Product Change Notice (PCN)

PCN Number: PCN-0451201R-01

Product(s) Affected: PJ-056, PJ-035-SMT-TR

Comparison plastic housing as below:

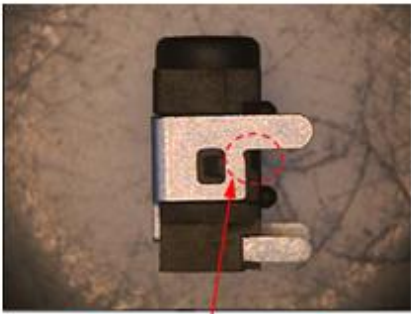
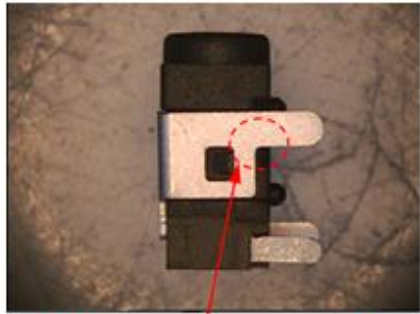
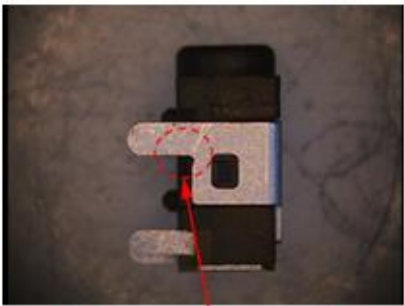
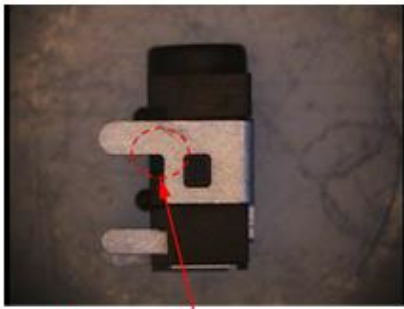
New version	Current version
Top	 <p>pin#3 marking at the back</p>	 <p>pin#3 marking on sides</p>
Back	 <p>thickness of pin#2 is 0.25mm</p>	 <p>thickness of pin#2 is 0.2mm</p>
Left	 <p>pin#3 with dent</p>	 <p>pin#3 without dent</p>
Right	 <p>pin# 3 with dent</p>	 <p>pin#3 without dent</p>

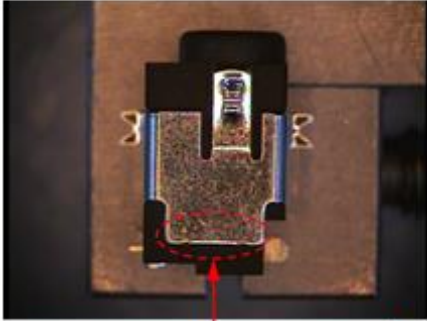
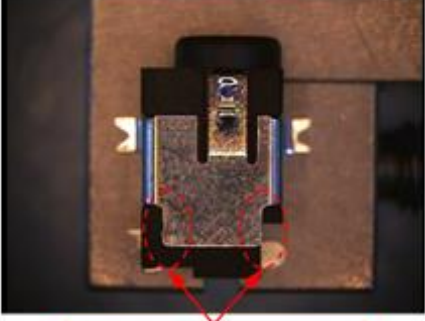
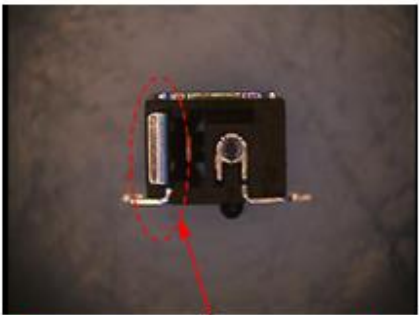
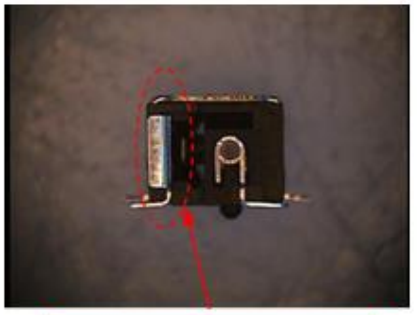
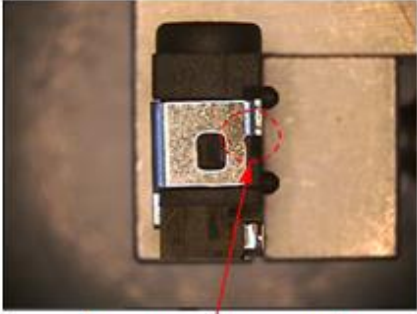
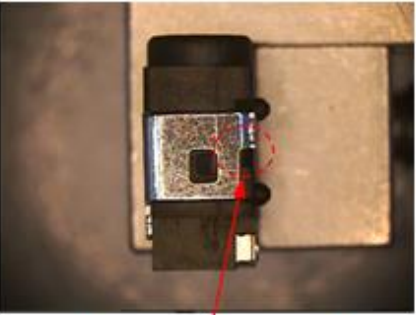
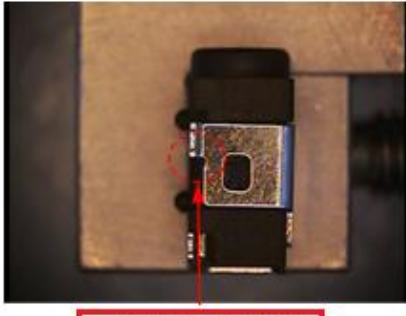
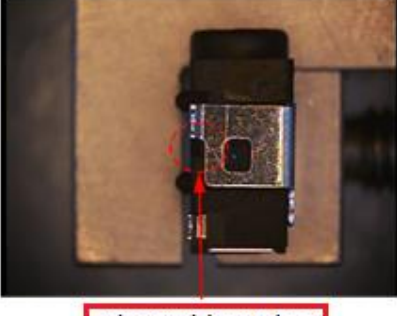
New version	Current version
Top	 <p data-bbox="363 622 730 678">pin#3 marking at the back</p>	 <p data-bbox="1018 622 1326 678">pin#3 marking on sides</p>
Back	 <p data-bbox="363 1050 722 1106">thickness of pin#2 is 0.25mm</p>	 <p data-bbox="1007 1050 1342 1106">thickness of pin#2 is 0.2mm</p>
Left	 <p data-bbox="432 1487 684 1543">pin#3 with dent</p>	 <p data-bbox="1042 1487 1294 1543">pin#3 without dent</p>
Right	 <p data-bbox="419 1892 667 1946">pin#3 with dent</p>	 <p data-bbox="1050 1892 1294 1946">pin#3 without dent</p>
